Addendum No. 1

Project No: 22132

Project: **Proposed Mixed-Use Building 510 & 520 Taunton Rd E**
GAY COMPANY LIMITED

The following information supplements and/or supersedes the bid documents issued on September 28, 2026

1 / S201 — FOUNDATION PLAN
1 : 100

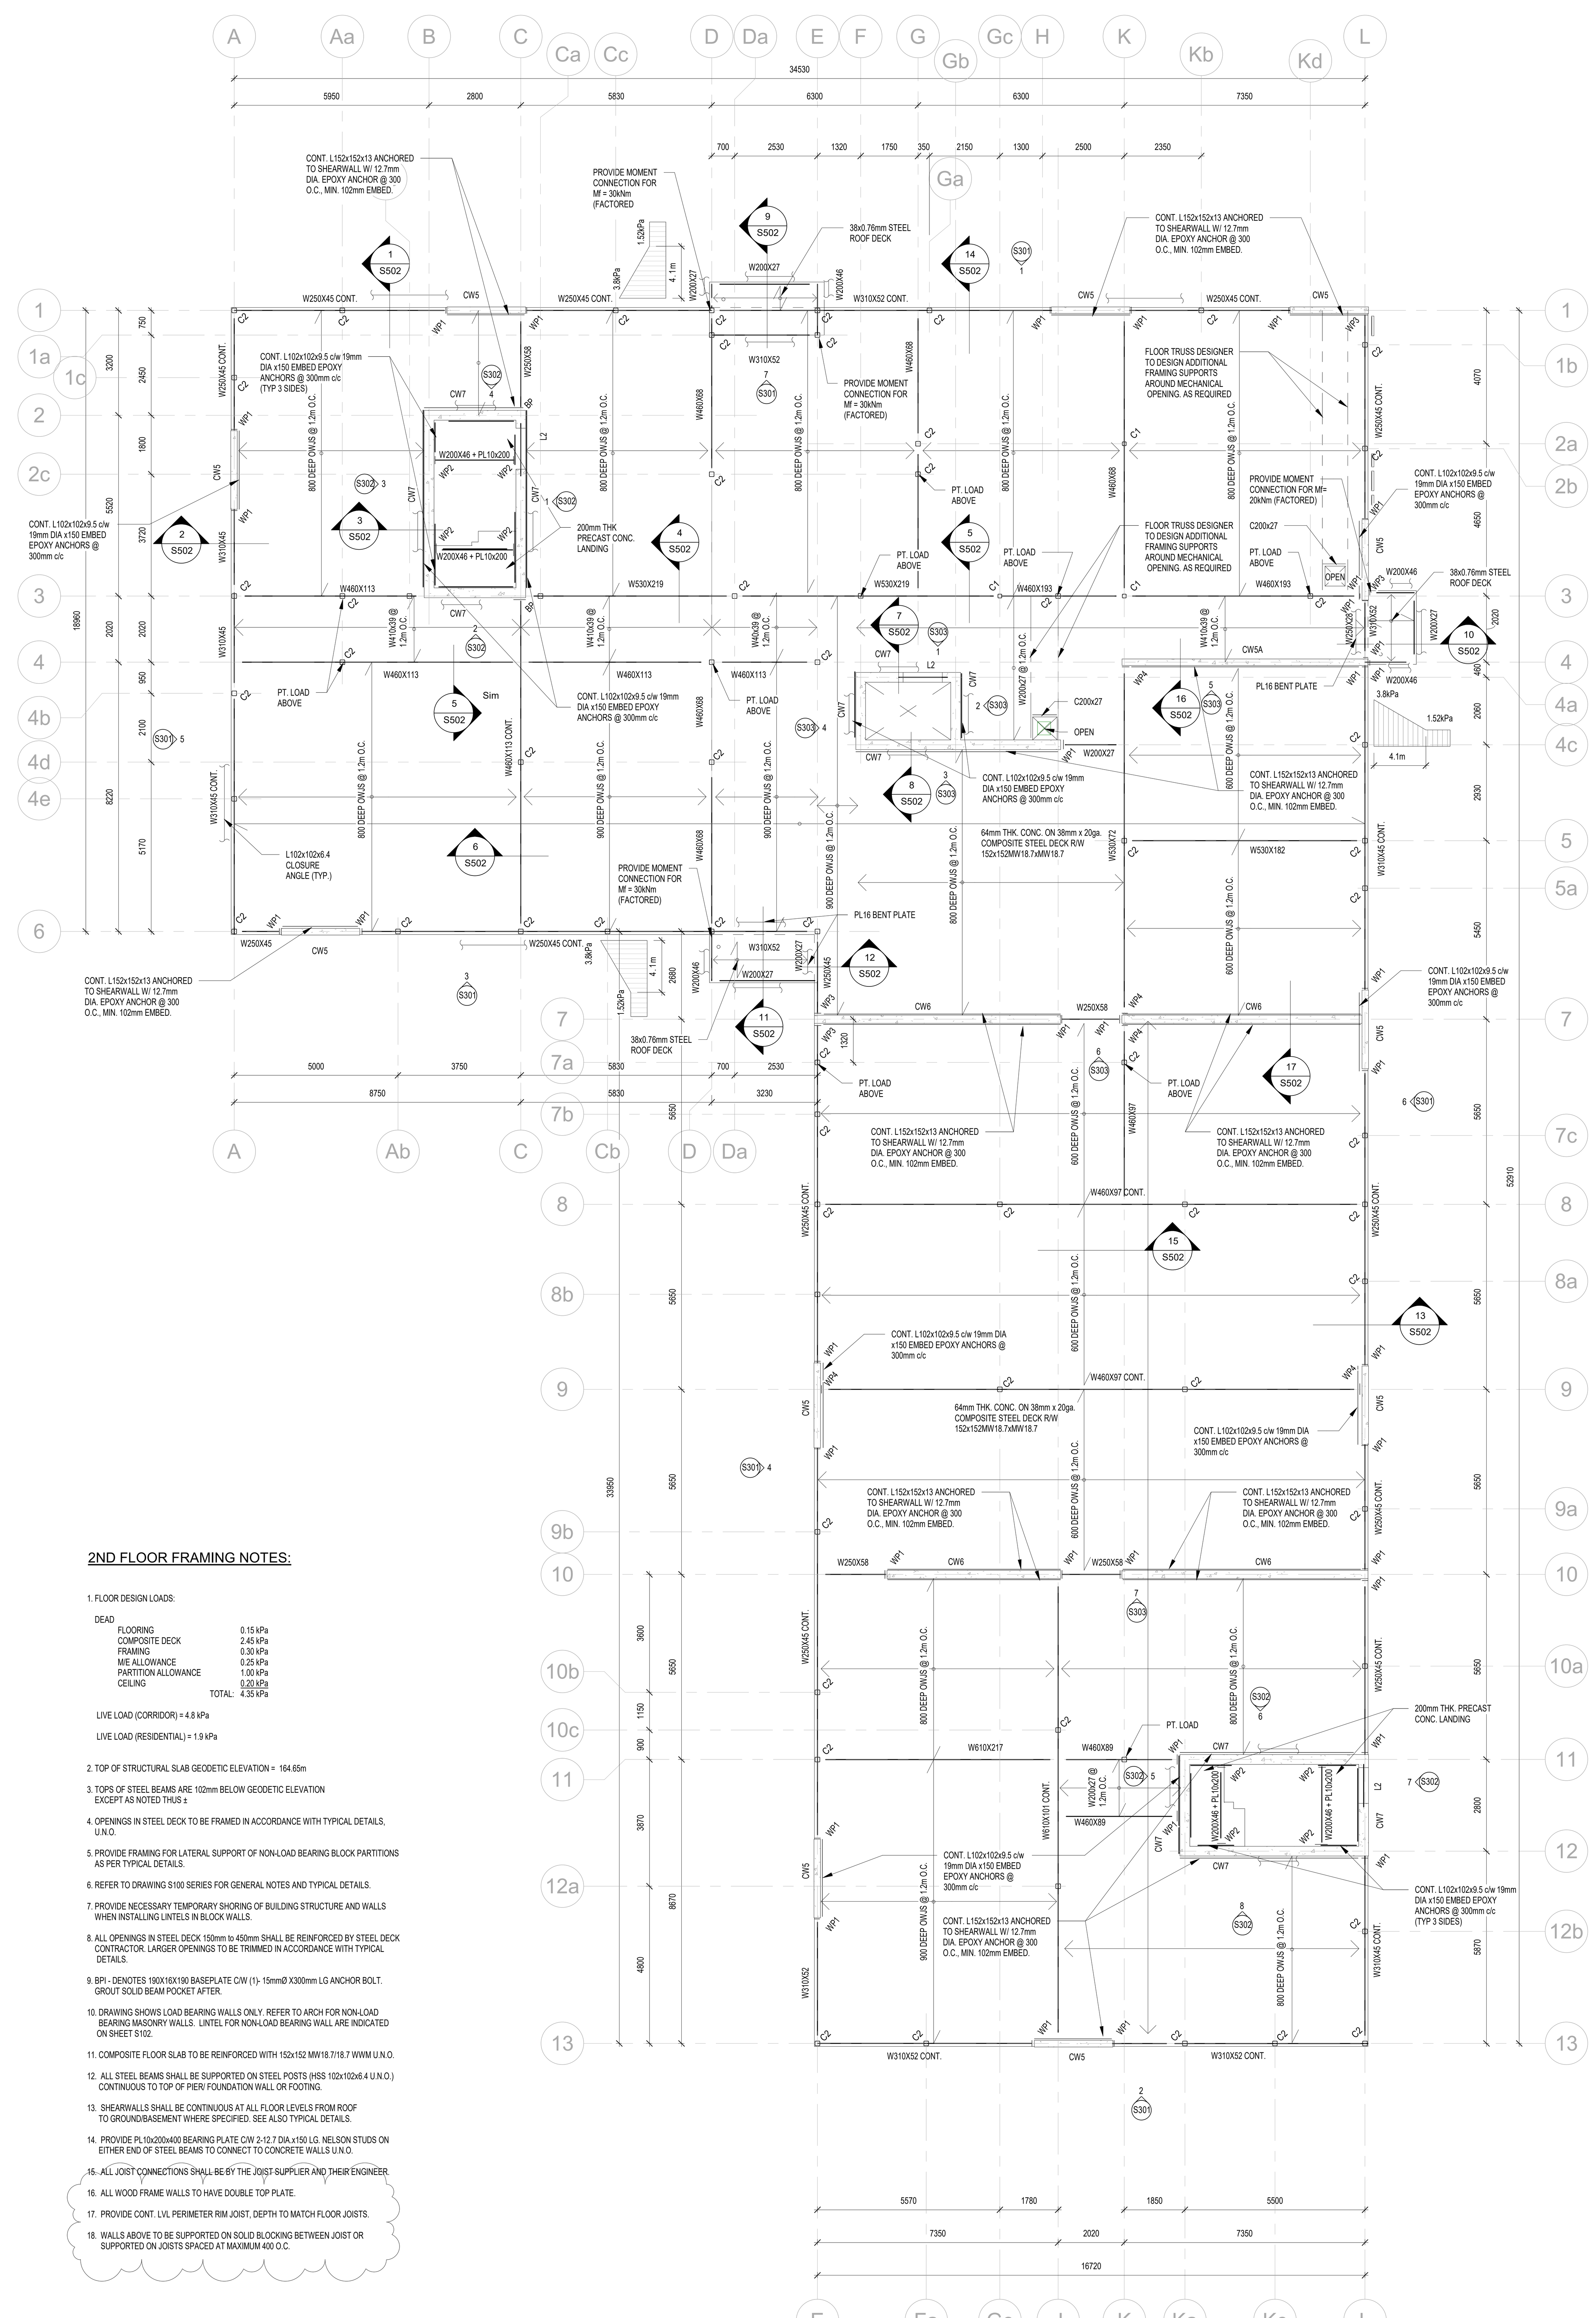
.1 Foundation plan notes added to 1/S201.
.2 Notes 16-18 added under SECOND FLOOR FRAMING NOTES, 2/S201.

2 / S201 — 2nd FLOOR FRAMING PLAN
1 : 100

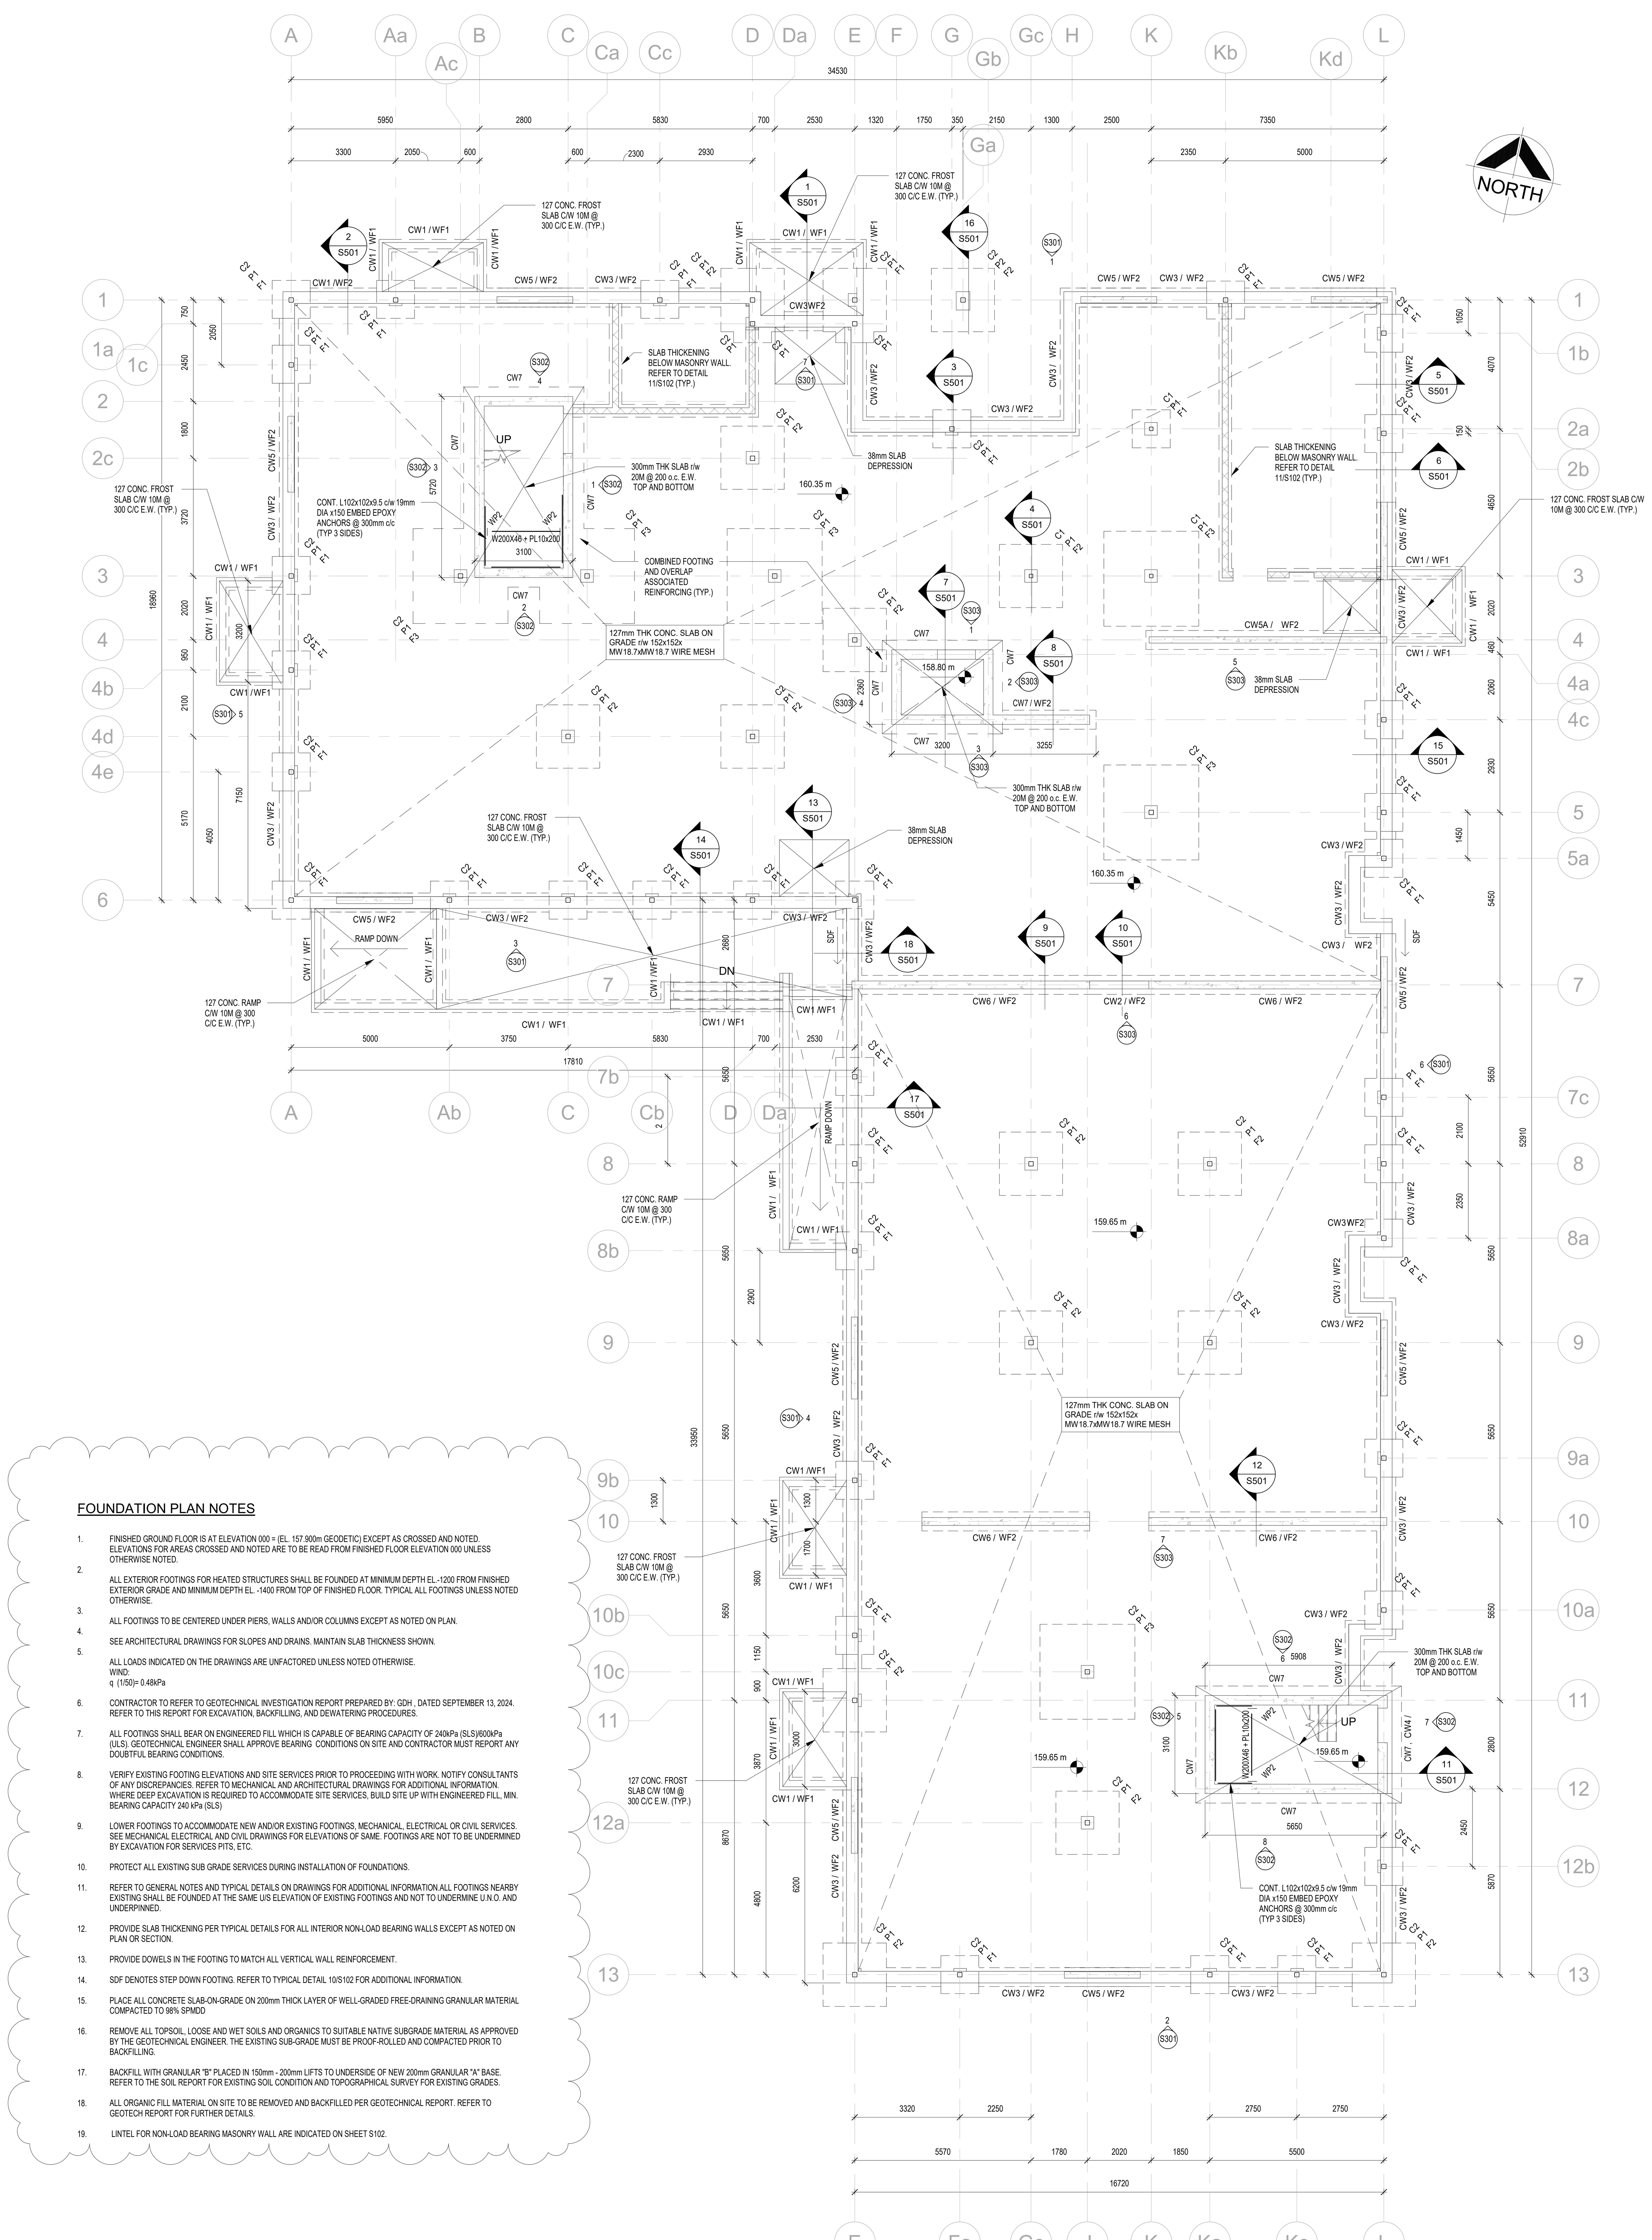
.1 Notes 16-18 added under FLOOR FRAMING NOTES, 1/S202.
.2 Notes 12-14 added under ROOF FRAMING NOTES, 2/S202.
.3 Roof plan and floor plans updated to show ledgers along concrete shearwalls. See 1/S202 and 2/S202.

18. WALLS ABOVE TO BE SUPPORTED ON SOLID BLOCKING BETWEEN JOIST OR SUPPORTED ON JOISTS SPACED AT MAXIMUM 400 O.C.
